**AMENDMENT NO. 2**

**CENTRAL ALKIMOS**

**AGREED STRUCTURE PLAN NO. 95**

# PART 2 - EXPLANATORY REPORT

Figure 2 – Proposed Primary School Location

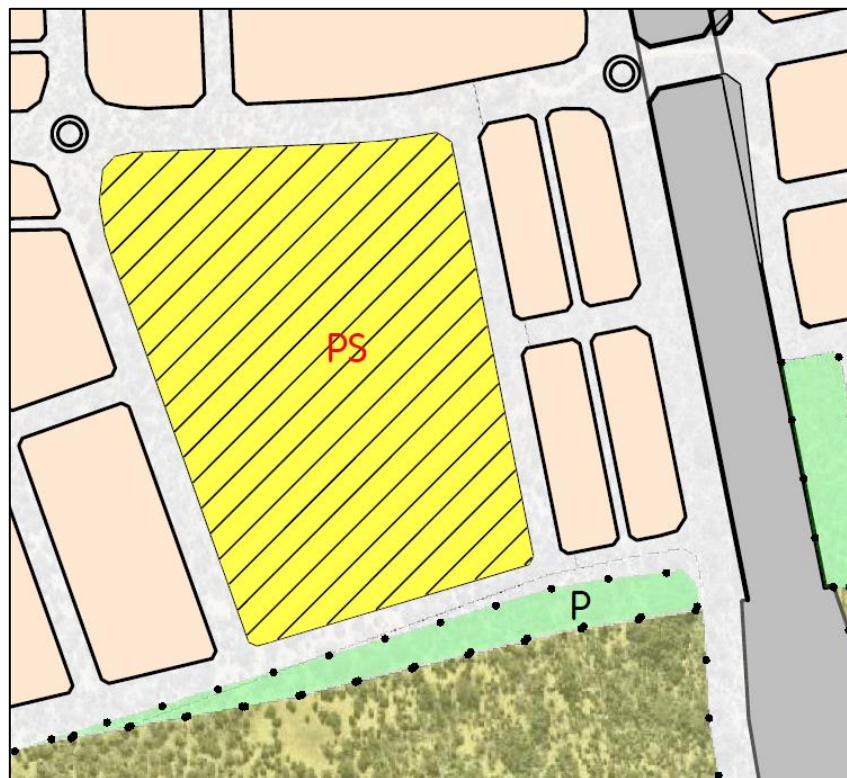
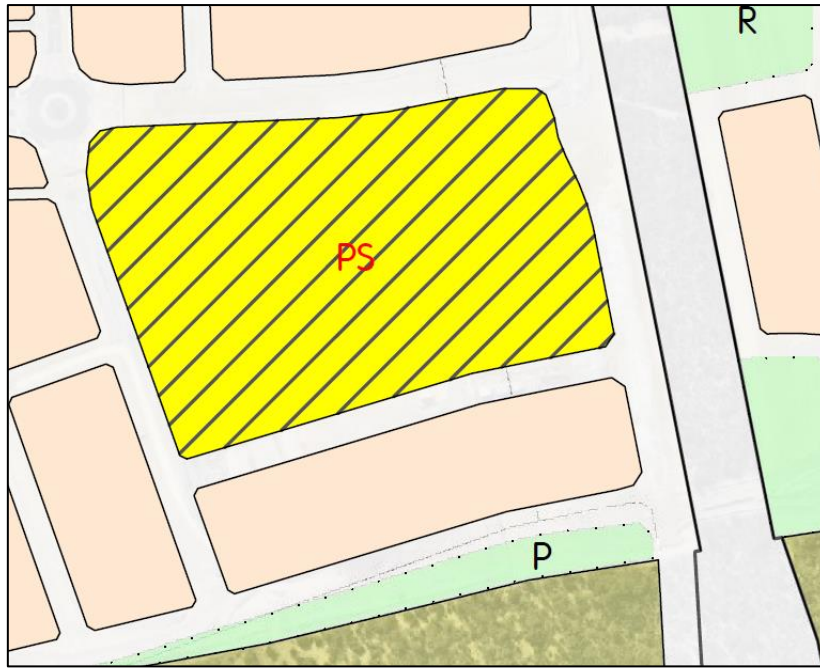
### Reorientation of Primary School

In respect to the reorientation of the primary school site, one of the reasons for this is that the proposed roundabout adjacent to the subject bridge is partially located within the rail reserve. As the bridge is being removed, the proposed roundabout needs to be relocated to wholly within the structure plan area. The relocated roundabout impacts on the currently proposed terrace lots to the south-west, resulting in non-conventional lot boundary shapes. A large primary school site is considered more appropriate to address these lot boundary shapes than residential lots.
